GFA AD 446
(ISSUE 1)

GFA AIRWORTHINESS DIRECTIVE

SUBJECT: Correct Safety Locking of the landing gear drive.

ROLLADEN-SCHNEIDER Flugzeugbau GmbH LBA-Nr. EB - 4	Technical Bulletin No. 3045 / 4036	all LS3 LS4 LS4-a	Page 1/2
			Edition July 93

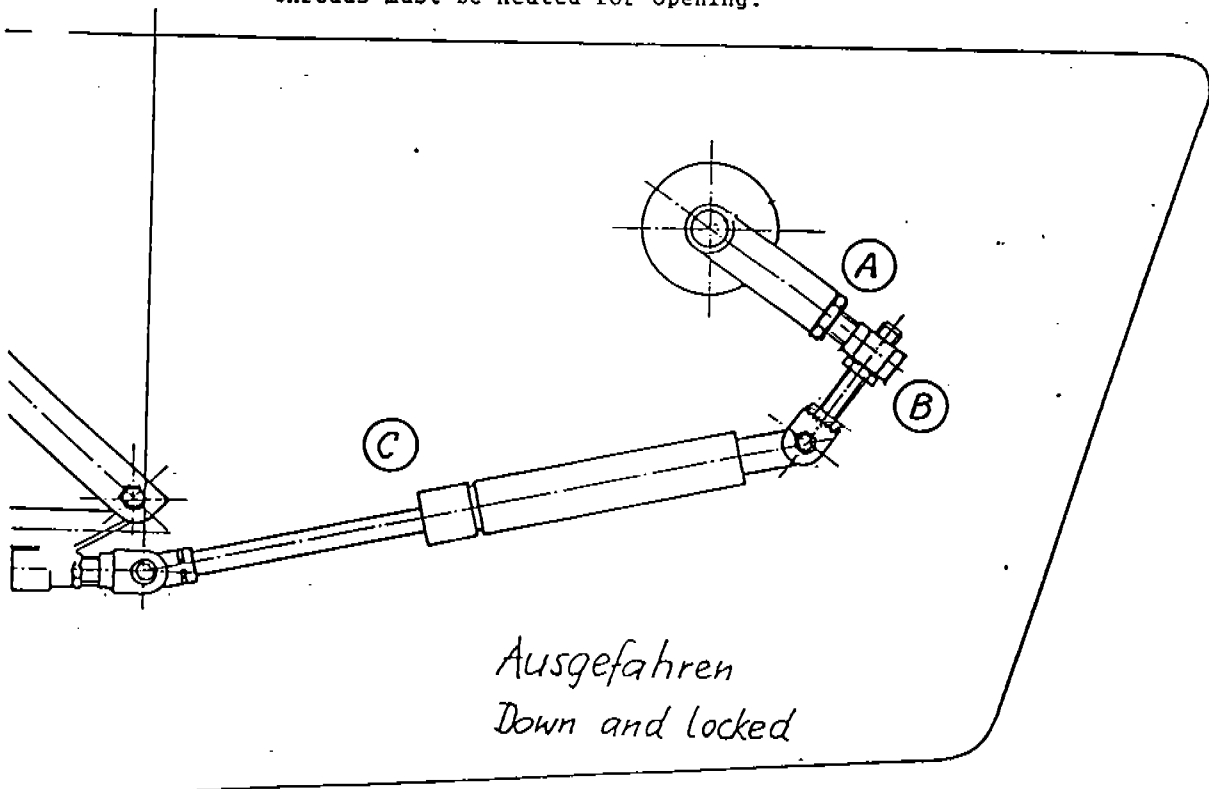
ACTION REQUIRED: Before next flight and each time the undercarriage is dismantled the locking nuts A and B in the figure in Technical Note 3045/4036 must be checked for correct torque and secured using Loctite of medium strength (removable) or an equivalent product. The correct torque values are shown in the Technical Note.

MATERIAL and : Check locking of nuts in the landing gear drive:
INSTRUCTIONS : A) Thread M10, Width over flats 19 mm,
torque 45 Nm (33 lb*ft)
B) Thread M8, width over flats 17 mm,
torque 25 Nm (18 lb*ft)
Additional safety by applying thread securing fluid (for
example: Loctite)

Drawing of landing gear drive at the left side of the landing gear box, adjustments at A and B, accessible after removal of the baggage compartment cover. When fitting a new gas strut C the following must be checked: During locking the gas strut must be compressed by about 5 to 8 mm (0.2 to 0.3 in) to ensure total strut force acting as preset load for locking.

- <A> Stellschraube mit Mutter, Gewinde M10
adjuster with nut, M10 thread
- Stellschraube mit Gabel, Gewinde M8
adjuster with fork, M8 thread

Additional safety by applying thread securing fluid (for example: Loctite). For later adjustments, these secured threads must be heated for opening.
